ADDENDUM 03, DELTA 03 DATE 05.01.2026

PROJECT: Santa Rosa Freestanding Emergency Room

ARCHITECT'S PROJECT NUMBER:
225014.00

OWNER: HCA Florida Fort Walton-Destin Hospital

1 LIGHTING - FIRST FLOOR PLAN
SCALE: 1/8" = 1'-0"

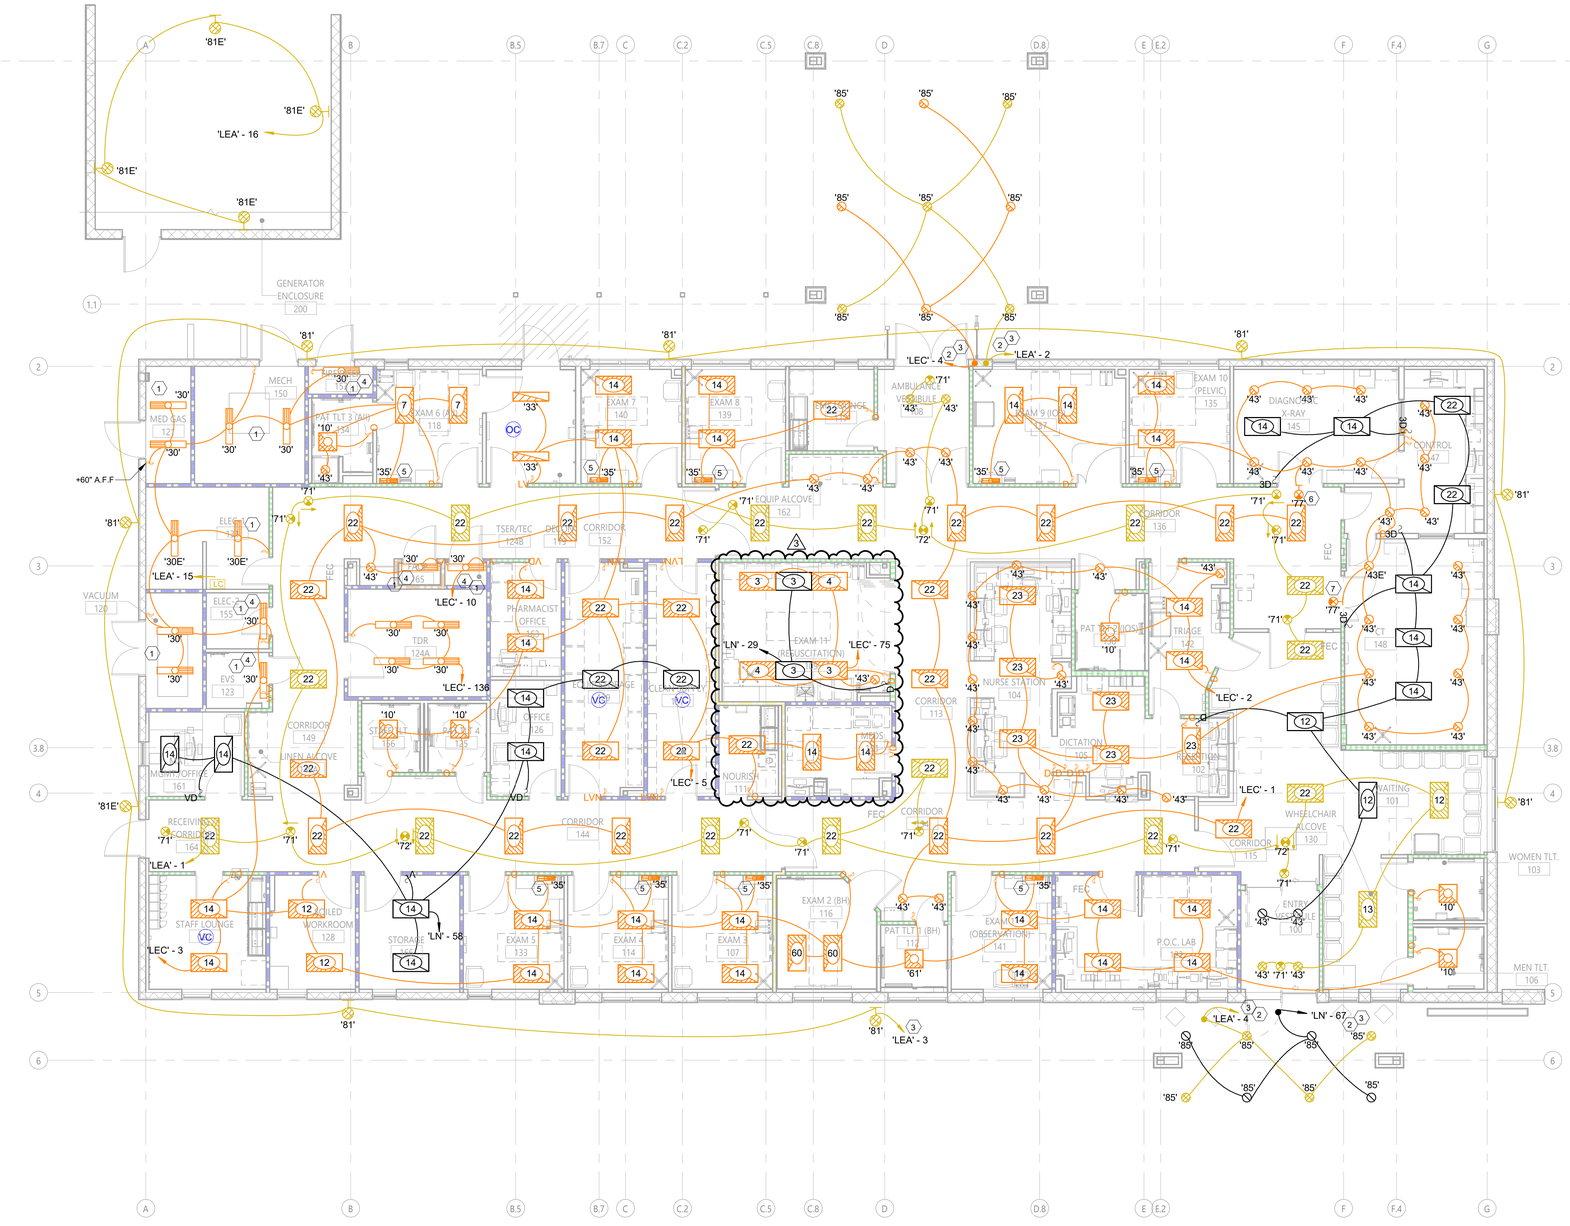
1. Revised lighting layout to match architectural floor plan changes for the resuscitation, nourish, and meds room.

1 POWER - FIRST FLOOR PLAN
SCALE: 1/8" = 1'-0"

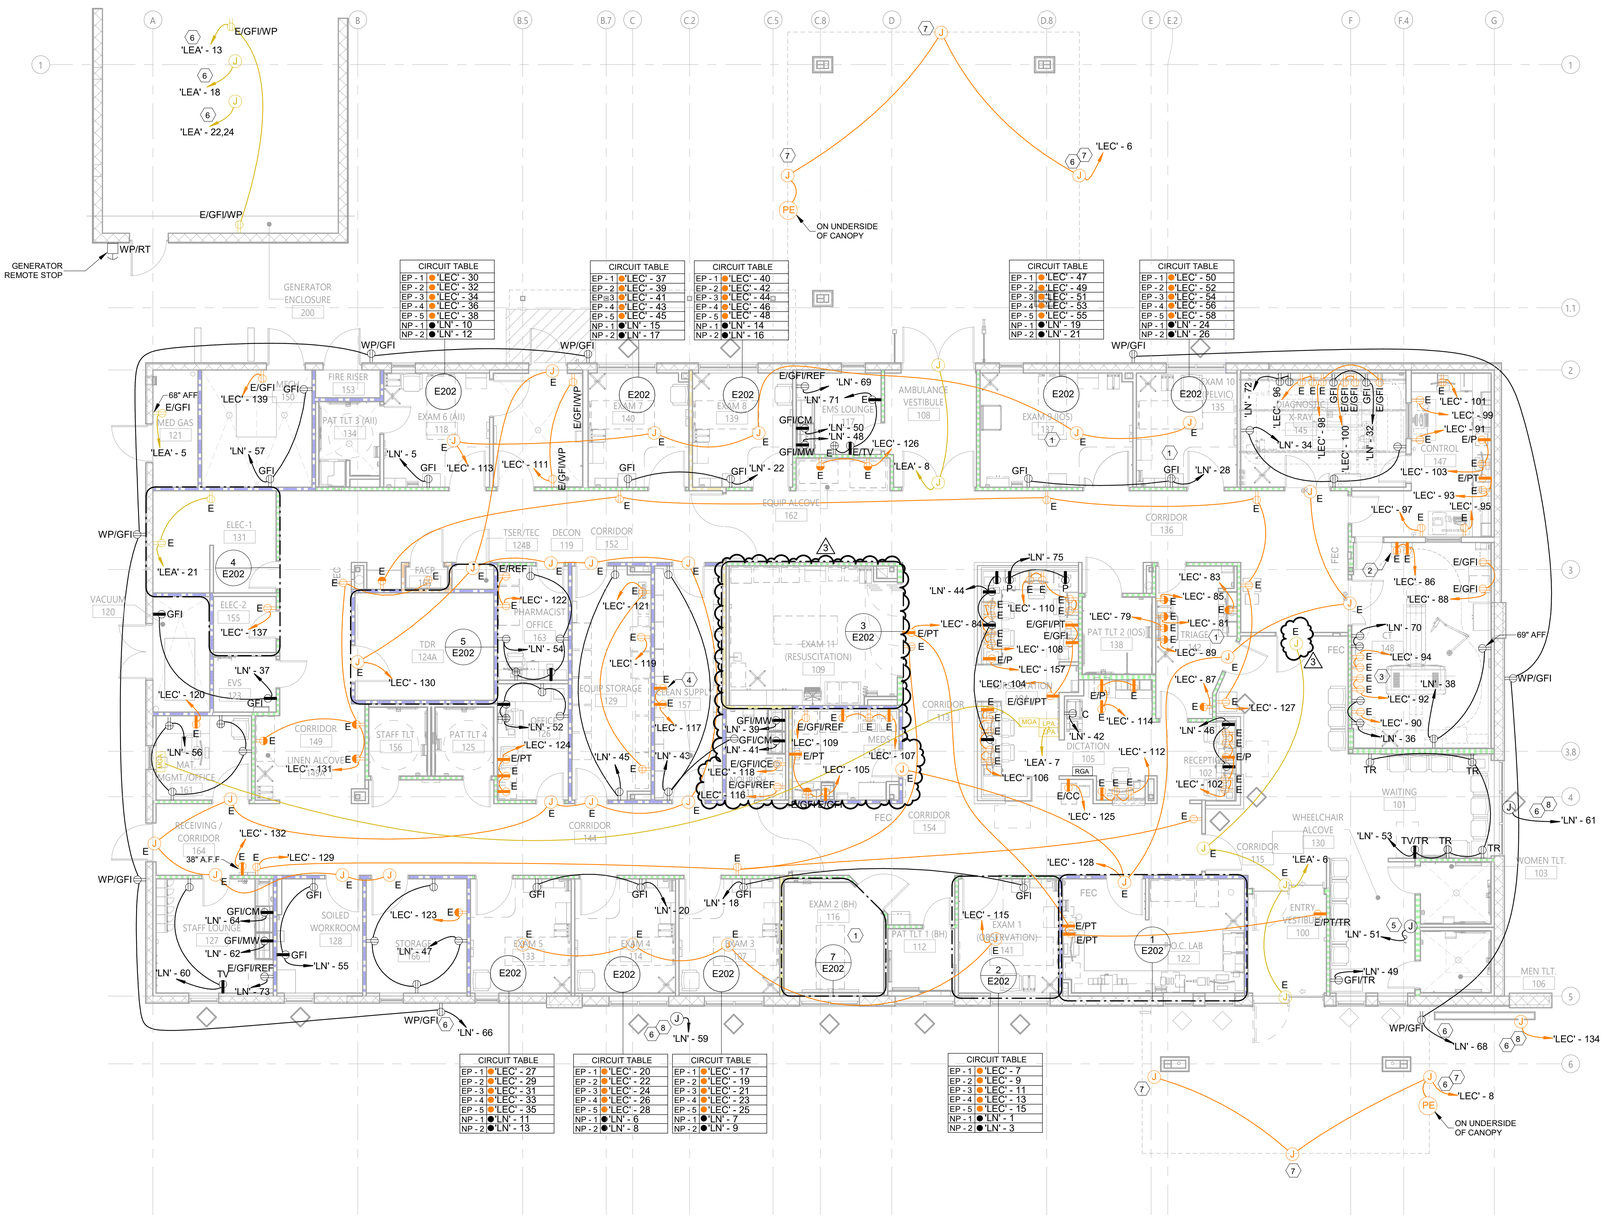
1. Revised power layout to match architectural floor plan changes in the resuscitation, nourish, and meds room.
2. Revised the electronically powered door in corridor 136 to be powered by the life safety branch.

1 SITE PLAN - PHOTOMETRICS
SCALE: 1" = 20'-0"

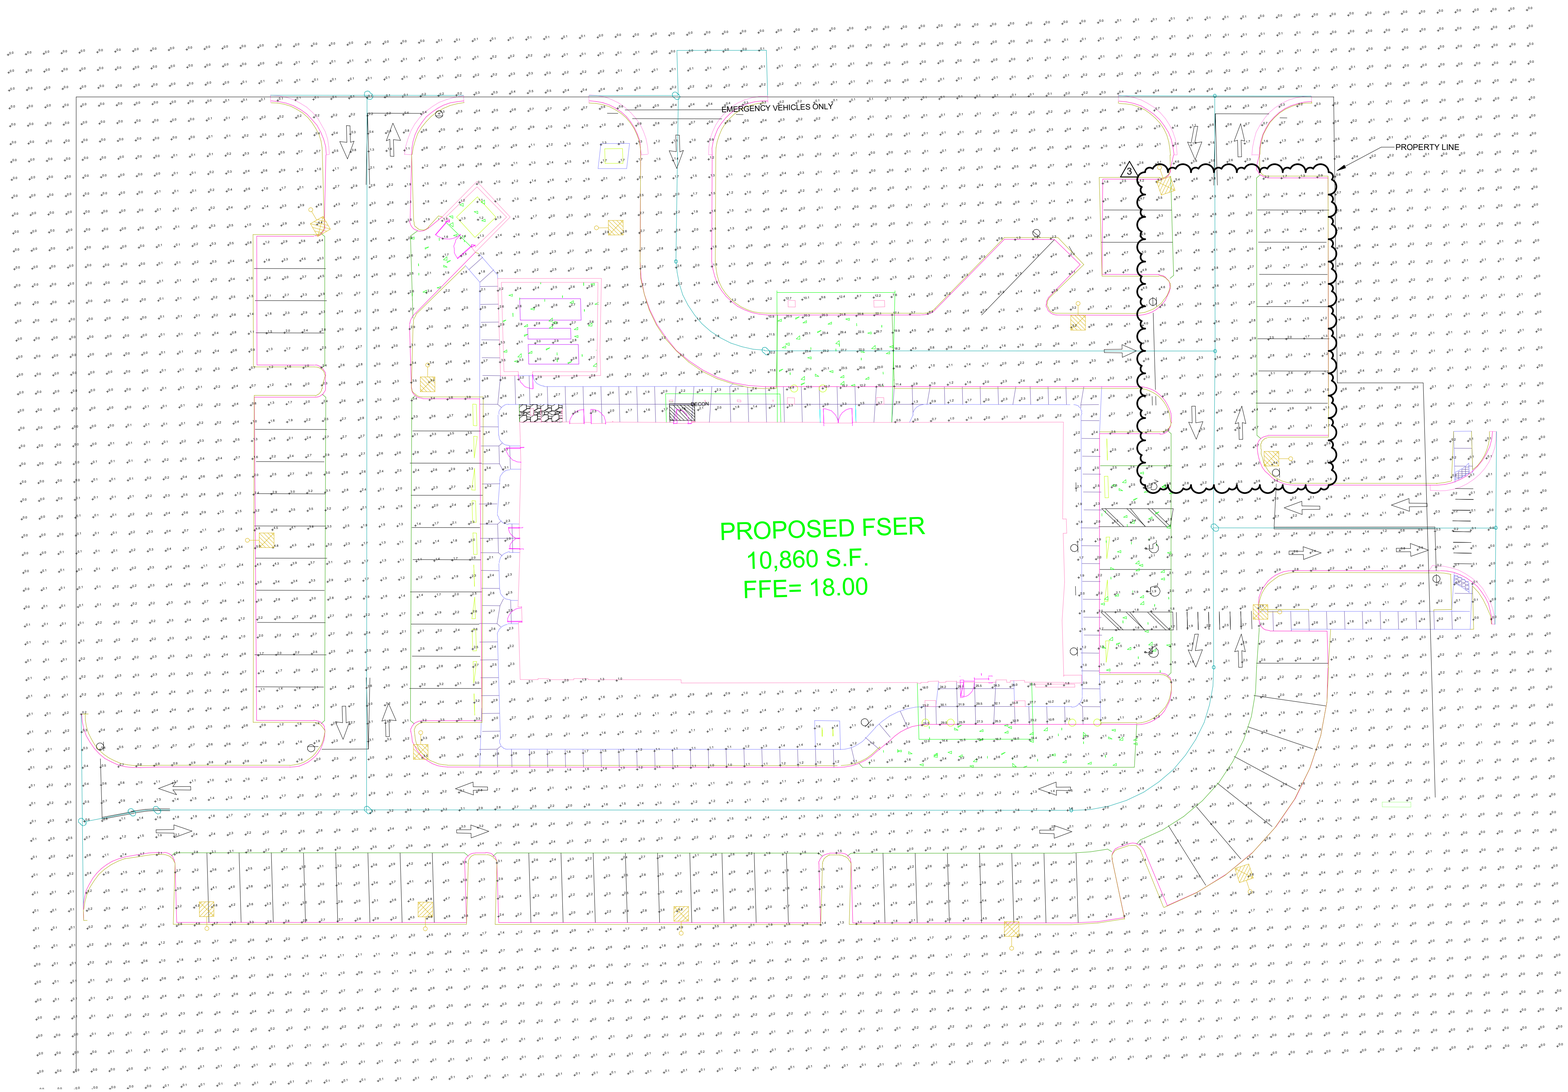
1. Added a page from the specified pole light to show full cutoff compliance and the available kelvin temperature options.
2. Revised the photometric plan to include at least on foot candle in the parking spaces.

1 TELECOMMUNICATIONS - FLOOR PLAN
SCALE: 1/8" = 1'-0"

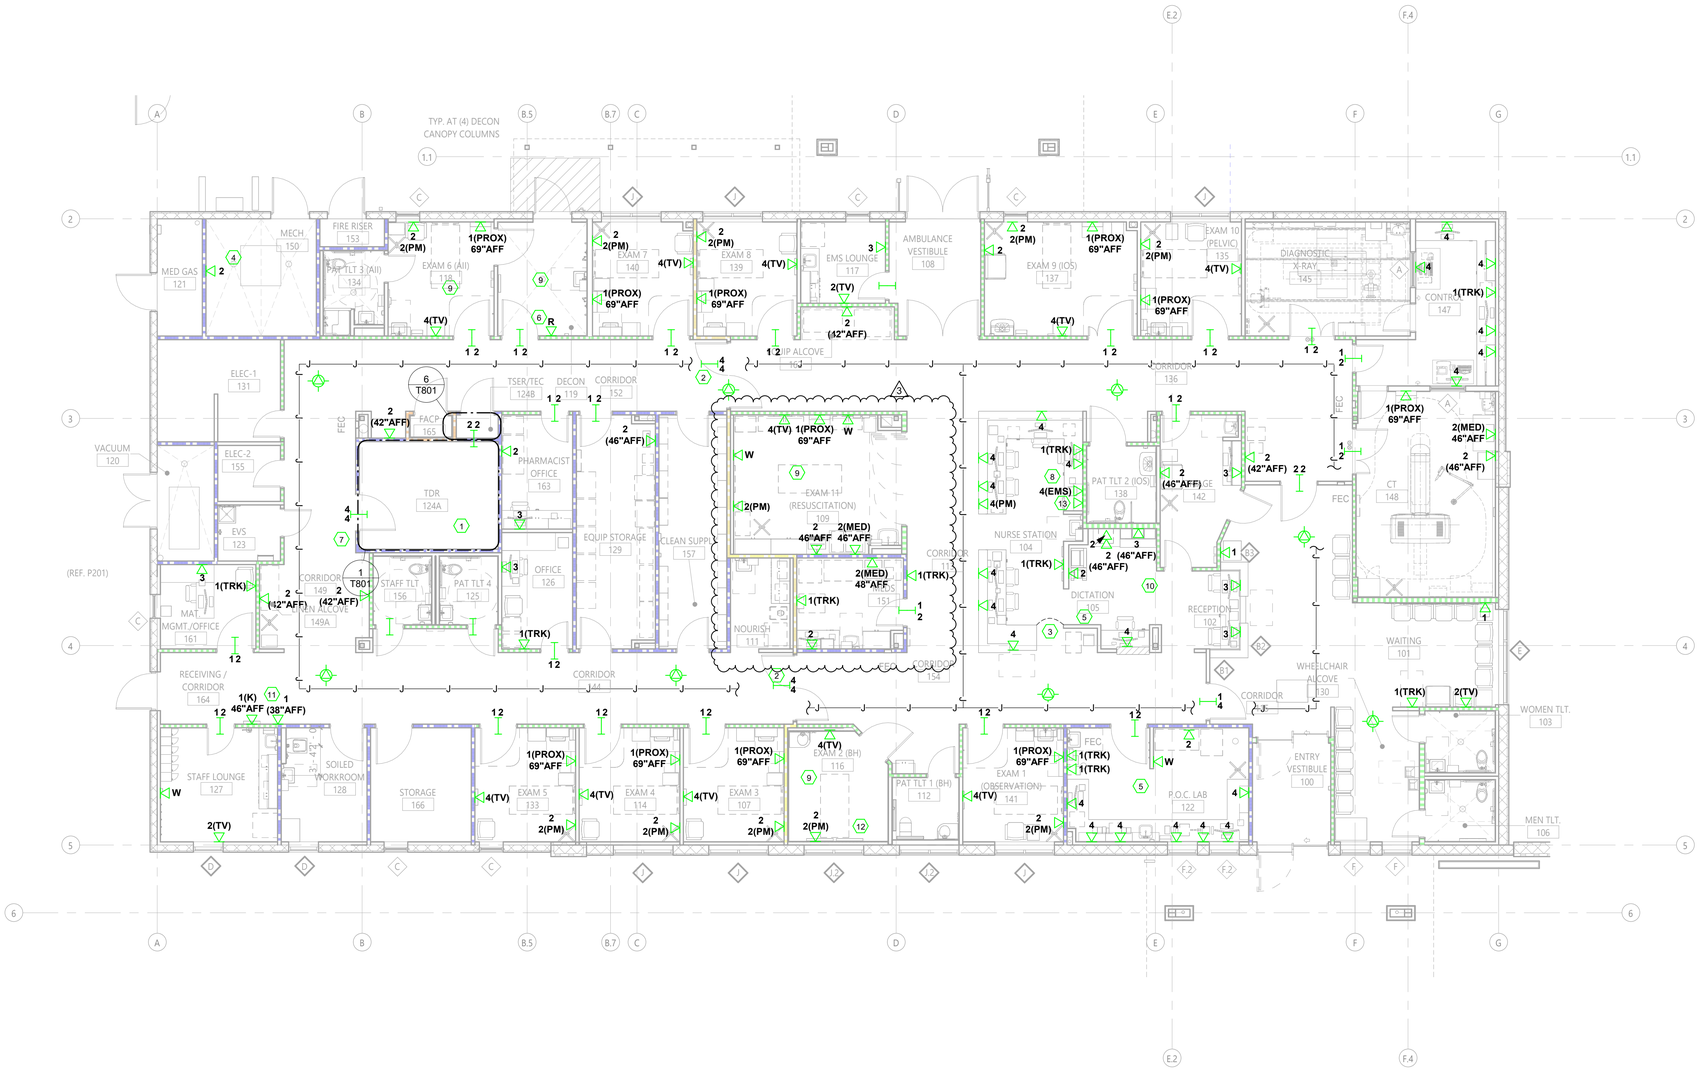
1. Revised data device layout to match architectural floor plan changes in the resuscitation, nourish, and meds room.

1 COMMUNICATION SYSTEMS - FLOOR PLAN
SCALE: 1/8" = 1'-0"

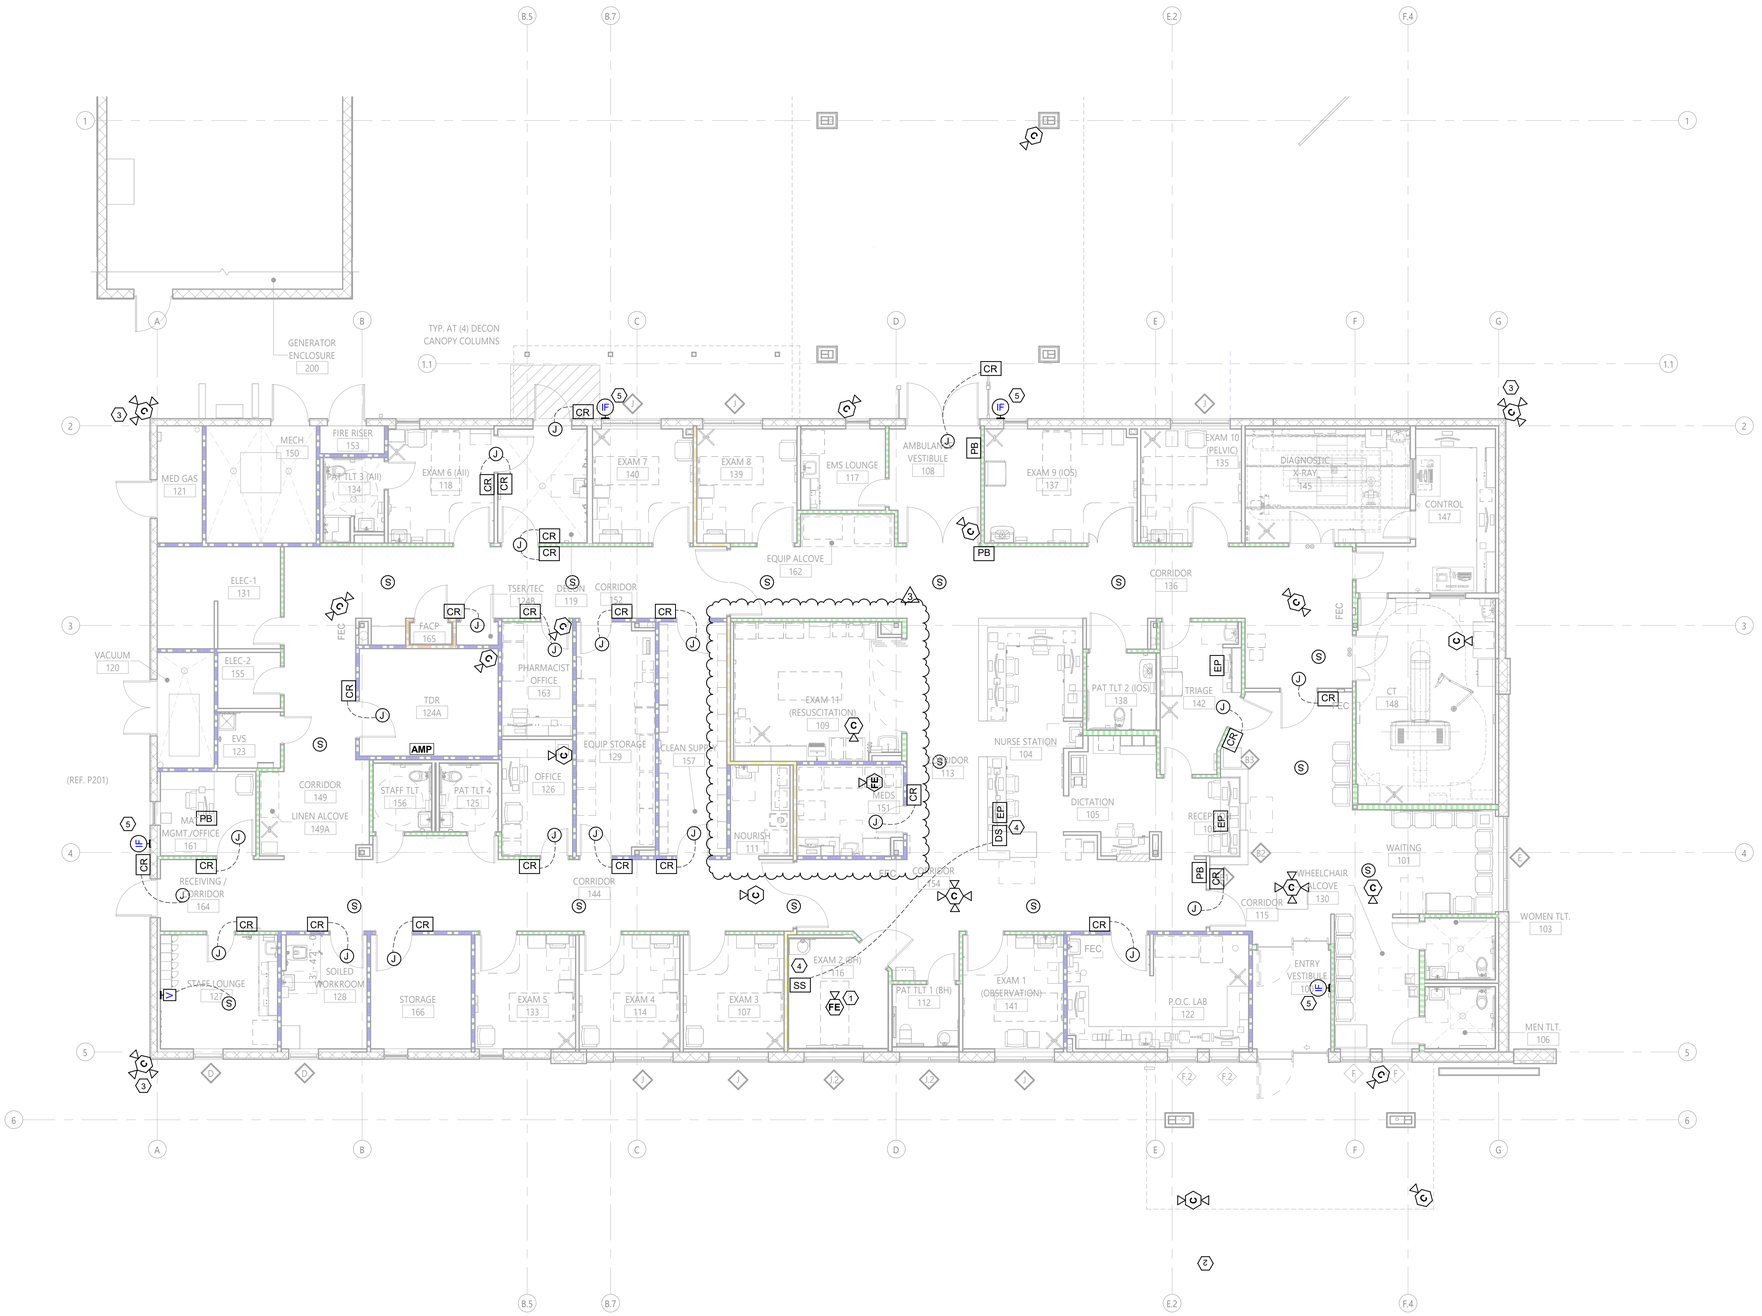
1. Revised security devices to match architectural floor plan changes in the resuscitation, nourish, and meds room.
